ADDENDUM #9

RE: Addendum #9
Electronic Access & Video Surveillance
Tyler Junior College
RFP #24-07

ARC

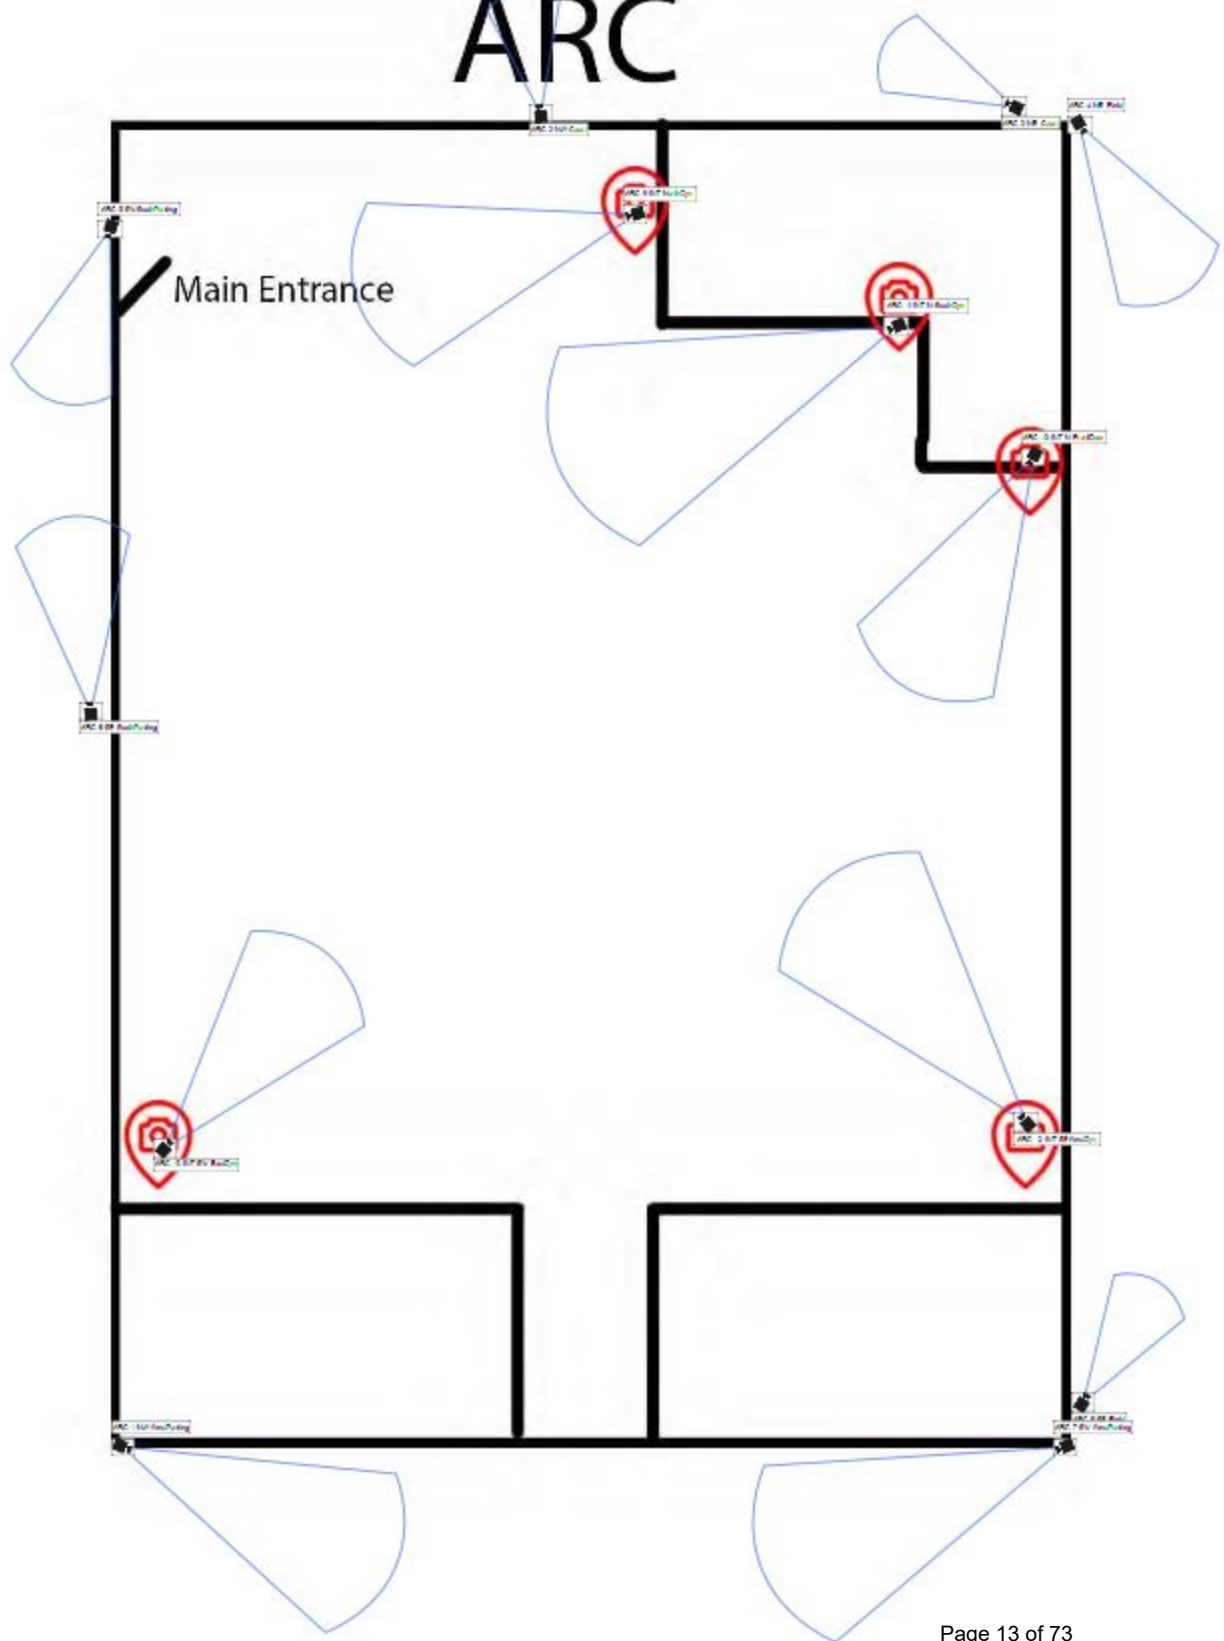
1. It's mentioned that 14 cameras are blurry. Is it possible the College could specify which cameras by building are blurry from VI?
2. Some counts don't have visual confirmation of counts:
 - a. Apache Recreation Center – Addendum says 13 cameras; however, the APC drawing provided is interior only and marks 5 cameras.
 - b. Rogers Student Center – Addendum says 56 cameras, but drawing counts are interior (21) and exterior (8) as marked.
 - c. Robert M. Rogers Nursing & Health Sciences – Addendum says 50 cameras, but drawing counts are interior (29) and exterior (14) as marked.

1. These cameras have been designated in the attached report with the camera name in red.
2.
 - a. An updated map of the Apache Rec Center has been attached.
 - b. There are additional cameras in the testing center that makes up the difference. It is a very small area and difficult to illustrate the locations and views. These are all

Claridge Hall - First Floor

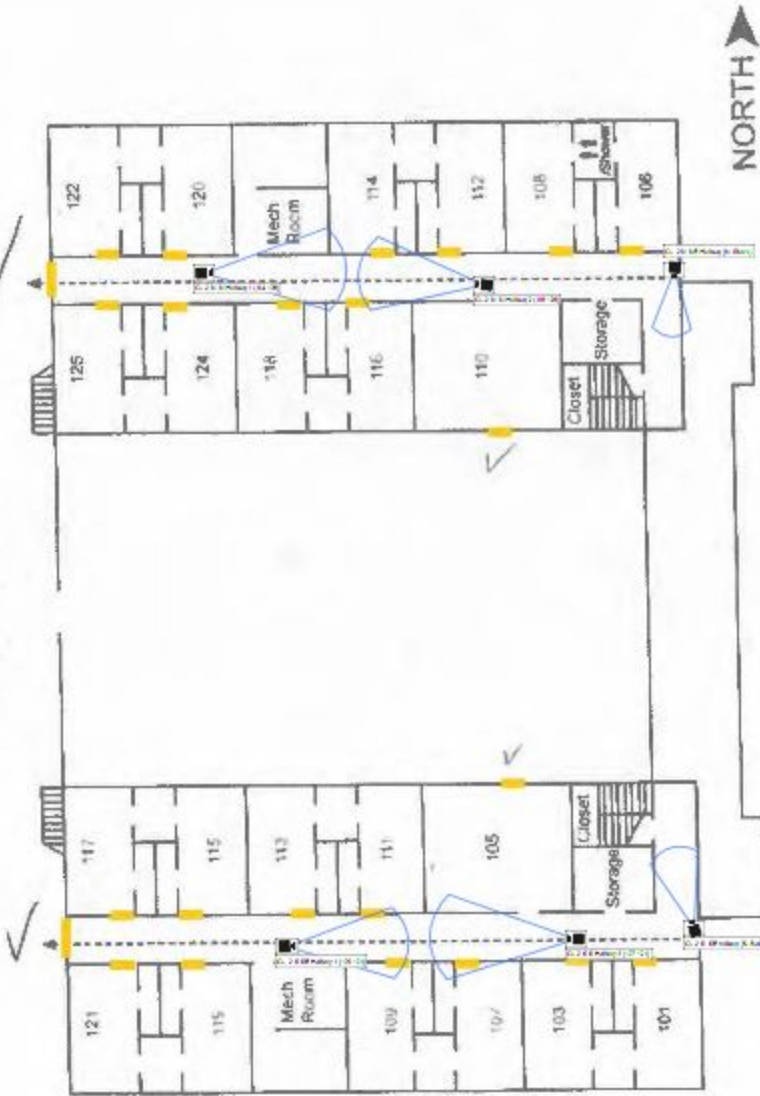
QUESTION #25: Sites that say they have interior cameras but do not have a marked map in Addendum 4: Claridge Hall.

ANSWER: An updated map has been attached.

Energy Center Level 1

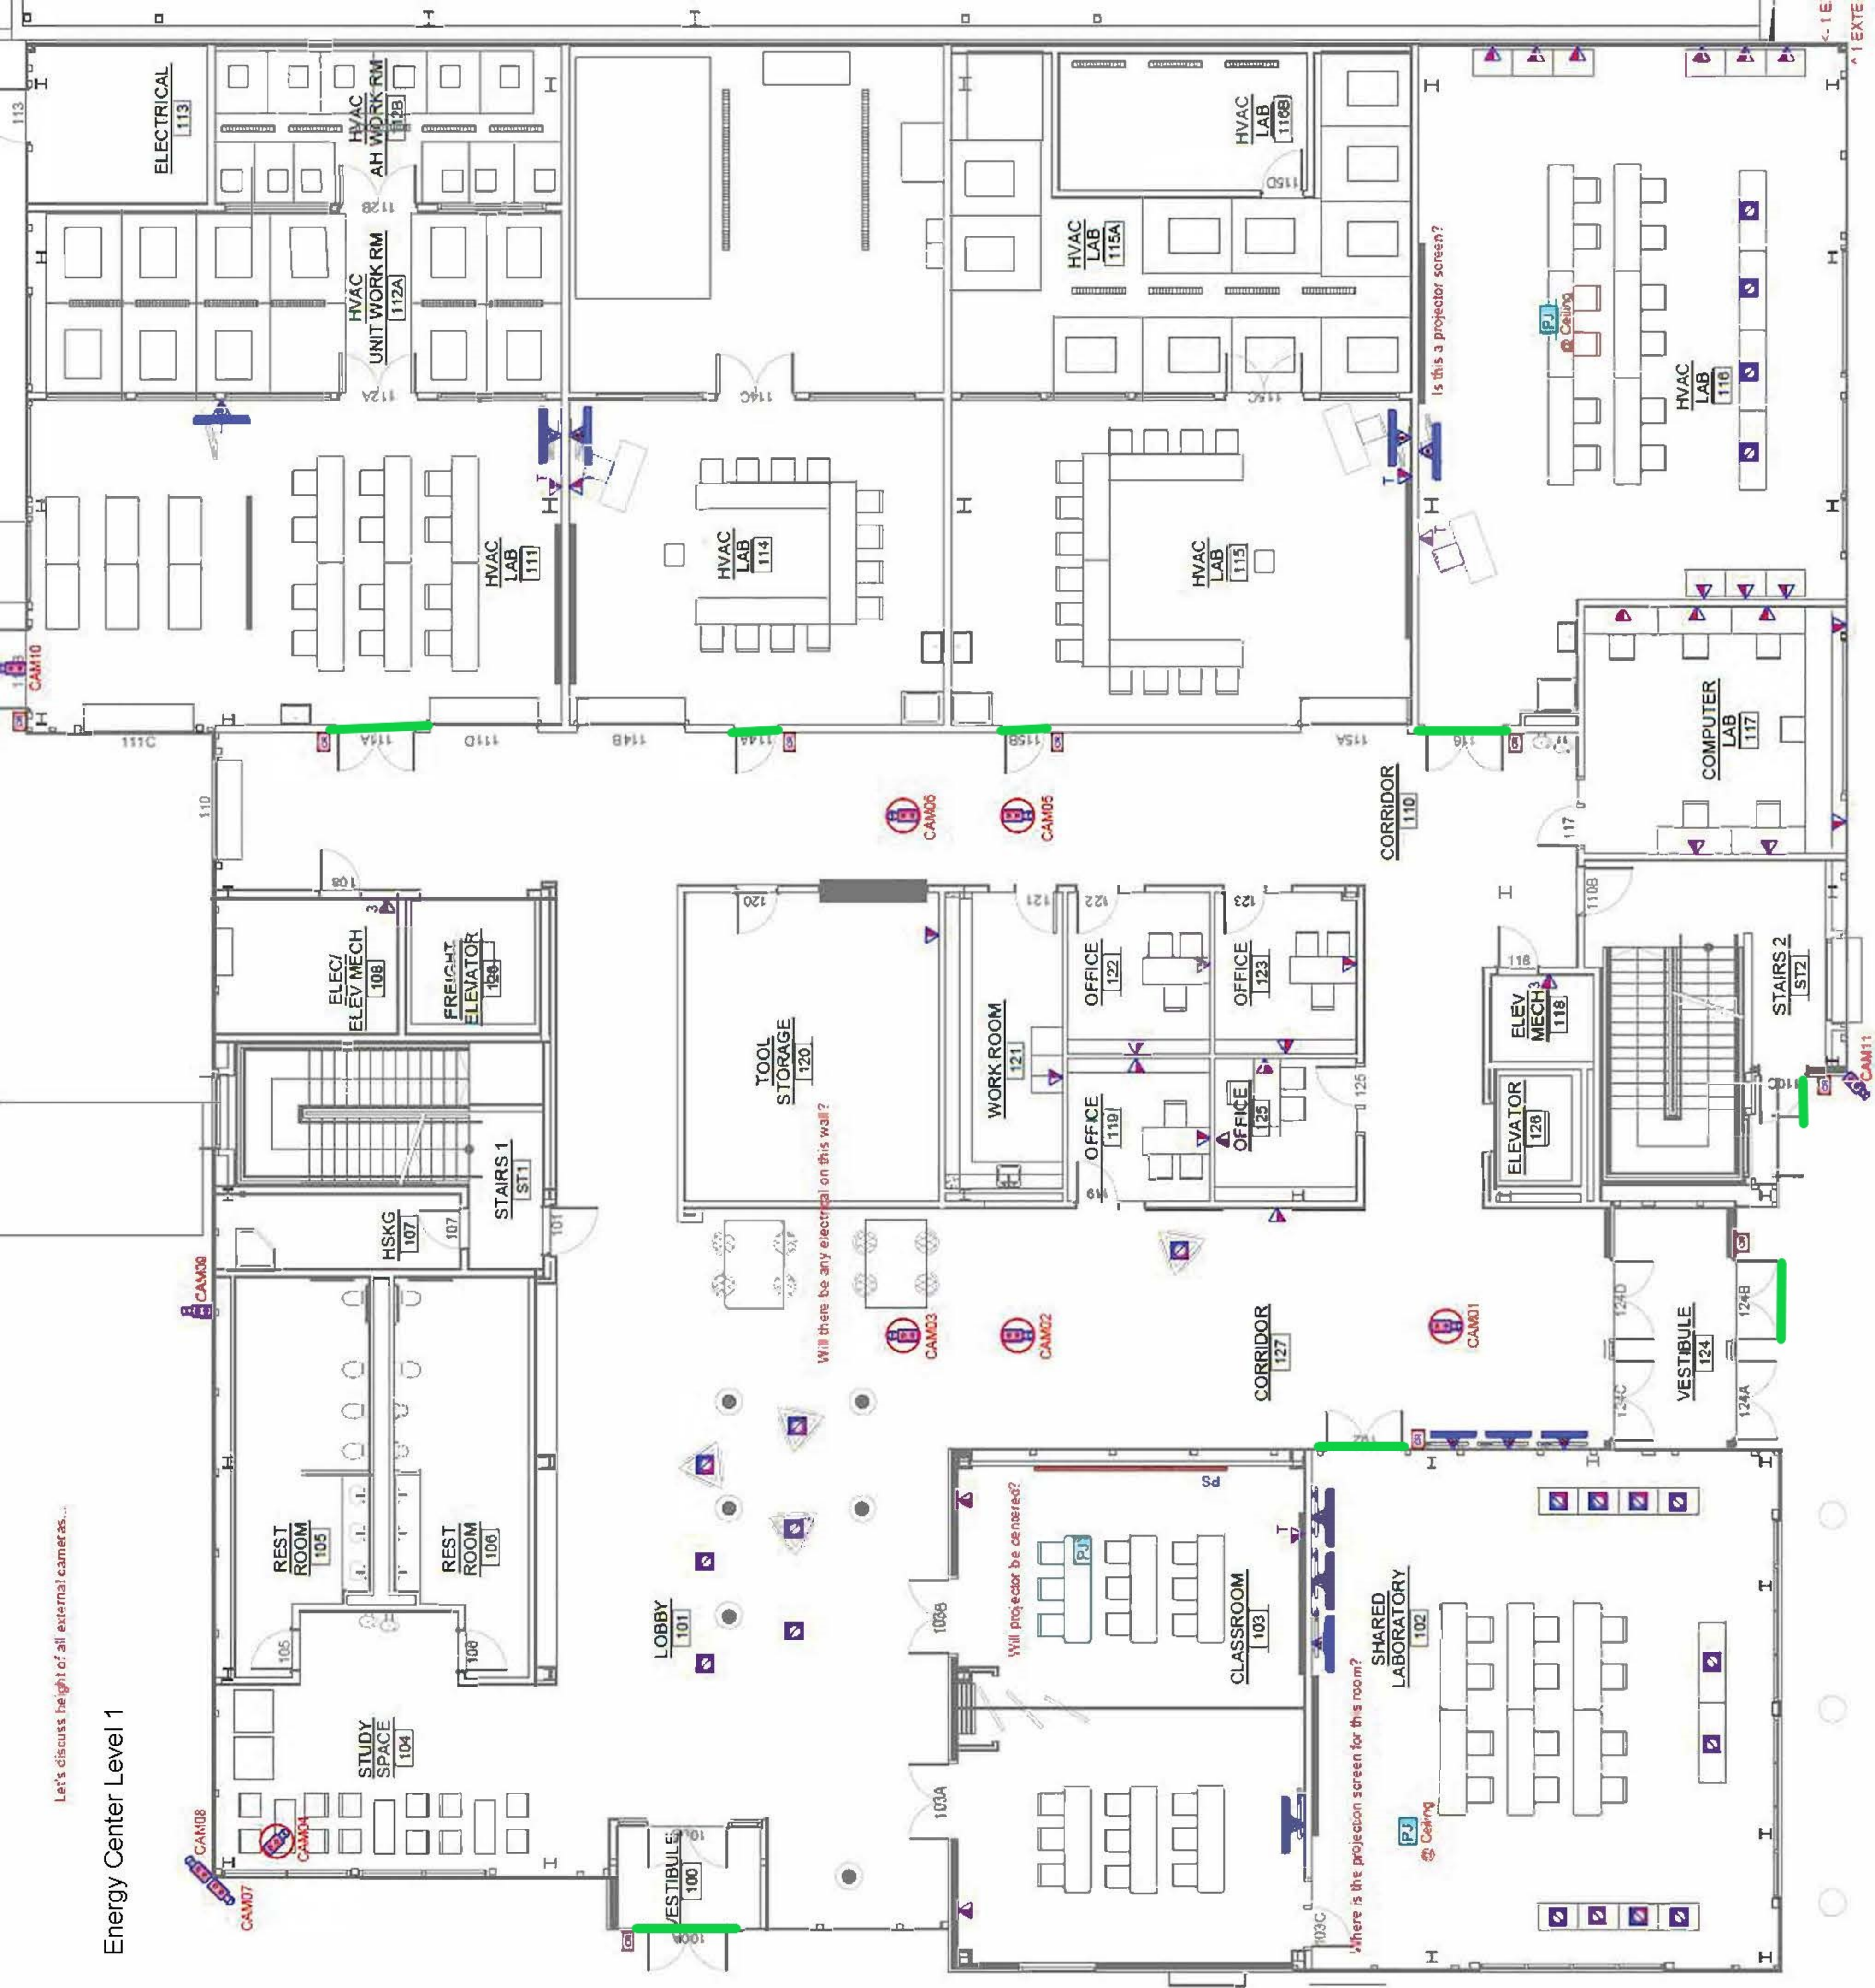
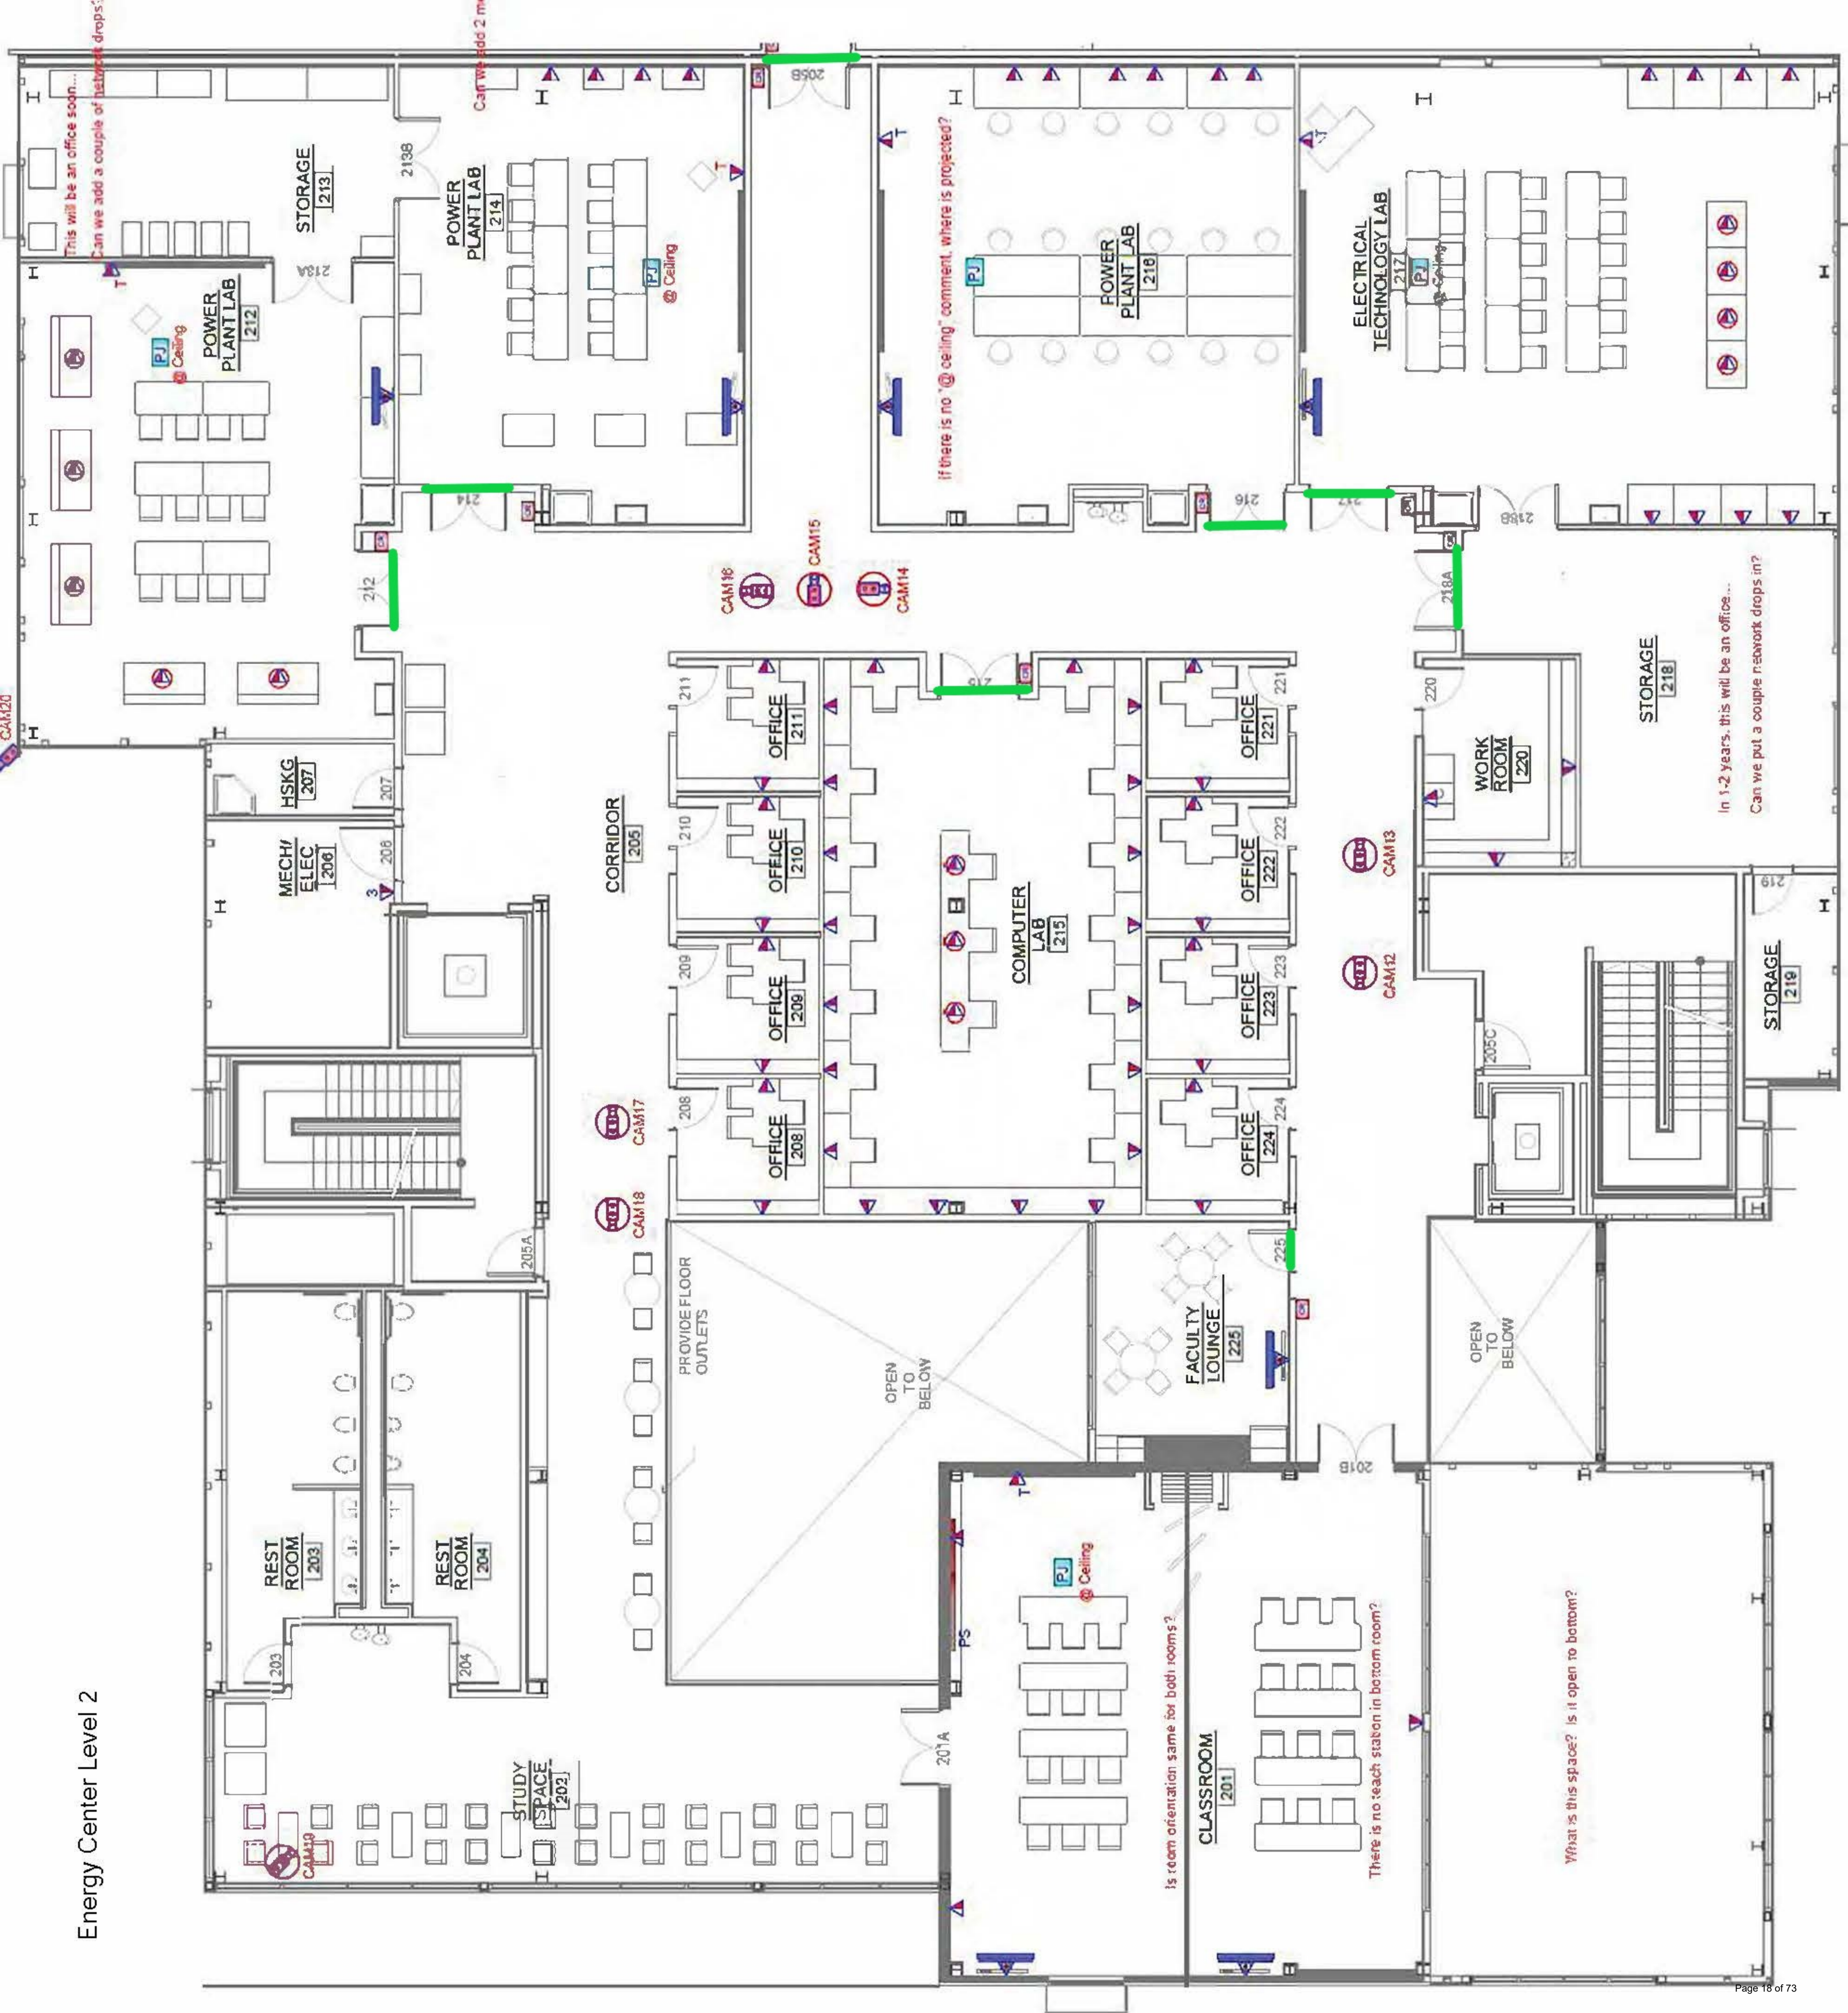
QUESTION #15: Addendum 5, Binder #2: Doors types, counts, closets are not given for the Energy Center 1st and 2nd floors, page 49 and 50.

ANSWER: The only IDF in the Energy Center is located on the 3rd floor where all data and door connections are located. Existing CBORD equipment is located in this IDF. There are no exterior doors on the 2nd floor of the Energy Center and the front doors currently have CBORD access control. Door information and counts should be included in the documentation provided by facilities. The marked-up blueprint was also included in the attachments.
